UNITED STATES PATENT AND TRADEMARK OFFICE

09/788,420

Office Action Summary	Application No. 09/788,420	Applicant(s) KWON ET AL.	
	Examiner TIMOTHY RUDE	Art Unit 2871

DETAILED ACTION

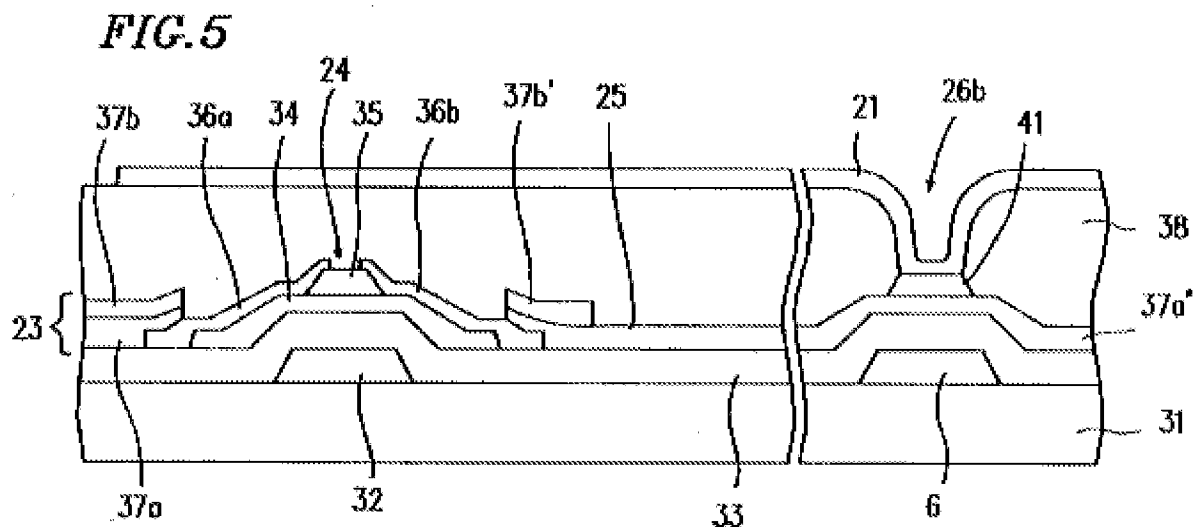
As to claims 1, 8-9, and 28, APA discloses a liquid crystal display (LCD) device (Fig. 1E) having a substrate (10), a first conductive layer (12A with no 12B; 12B is optional per Applicant's specification, page 9, per amendment filed 08 May 2007) and a pad layer (14A) on the substrate, wherein the pad layer is the portion of the first conductive layer that is formed at a pad region; a first insulating layer (16) on the substrate, the first conductive layer and the pad layer, the first insulating layer having a contact hole (above 14A) exposing a portion of the pad layer; (allowing electrical connection to 14A via contact hole above 14A);

a second insulating layer (26) on the third conductive layers, the second insulating layer having a first contact hole exposing a portion of the third conductive layers (contact hole for pixel electrode) and a second contact hole (hole for 30) exposing the portion of the pad layer exposed by the first insulating layer,

a fifth conductive layer (30) on the second insulating layer and electrically contacting the first conductive layers through the second contact hole; and

a sixth conductive layers, (24B and 14B), between and in contact with both the exposed portion of the third conductive layers (24A) and the fourth conductive layer, (28), and

between and in contact with both the pad layer, (14A), and the fifth conductive layer, (30),

wherein the sixth conductive layers are formed in the first contact hole and in the contact hole of the first insulating layer [sixth layers 24B and 14B exist at the bottoms of (Applicant's formed in) the contact holes], and wherein the first conductive layer and the pad layer are a single layer [formed from the same metal layer as shown in Applicant's Figure 1E (elements 12A and 14A) and Figure 3E (corresponding elements 34 and 36)].

APA does not explicitly disclose an embodiment wherein the sixth conductive layers are exclusively and entirely contained at the bottoms of the first contact hole and the bottom of the contact hole of the first insulating layer.

Tagusa teaches at Figure 5 an embodiment wherein such a metal layer, 41, may be deposited such that it is exclusively and entirely contained at the bottom of a contact hole, 26b, as an art recognized configuration suitable for the intended purpose of improving adhesion of the overlying conductive layer with the underlying conductive layer [col. 12, lines 4-34] which would improve yield and reliability [MPEP 2144.07].

Therefore, it would have been obvious to one having ordinary skill in the art at the time the invention was made to modify the reflective display invention of APA with the sixth metal layer(s) formed such that it is exclusively and entirely contained at the bottom of all contact holes as an art recognized configuration suitable for the intended purpose of improving adhesion of the overlying conductive layer with the underlying conductive layer [col. 12, lines 4-34] which would improve yield and reliability [MPEP 2144.07]. This would result in a change of configuration from that shown in Applicant's

Figure 1E (elements 12A and 14A) to Applicant's Figure 3E (to corresponding elements 34 and 36).
